RE: 16510 Topping Way

I reviewed the drawings and evaluated the neighborhood context. My comments and recommendations on the design are as follows:

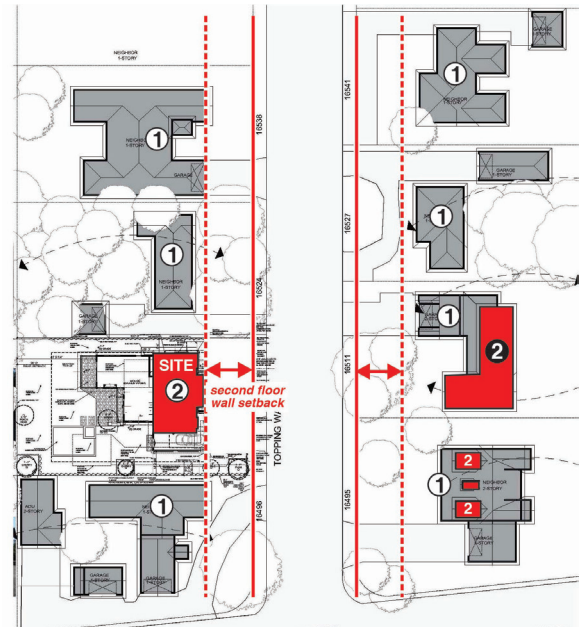
One of them has a two story wall at its front facade but it is screened from view by heavy tree landscaping and set back from the street - see photos below.

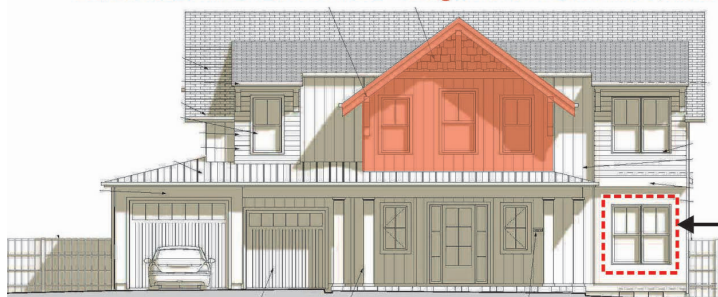
The second home has its second story imbedded within its roof form - see photo below.

In both cases the second floor facades are set much further back from the street than this proposed house - see illustration to the right.

Height and bulk at the front facade are close to the street and not consistent with Residential Design Guidelines 2.3.1, 2.3.2 and 3.3.2

1. **Utilize a shed roof on the front and rear elevations in lieu of the proposed projecting gable roofs.**
2. **Provide consistent trim on all windows and doors consistent with Residential Design Guideline 3.7.4.**

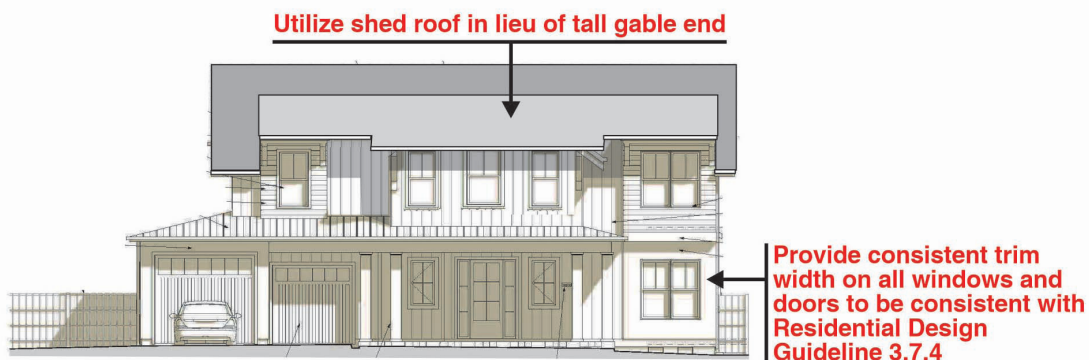
Window trim is smaller on some windows and may not be consistent with Residential Design Guideline 3.7.4

2. The windows shown are appropriate to the style but the width of trim shown on the various windows is not consistent
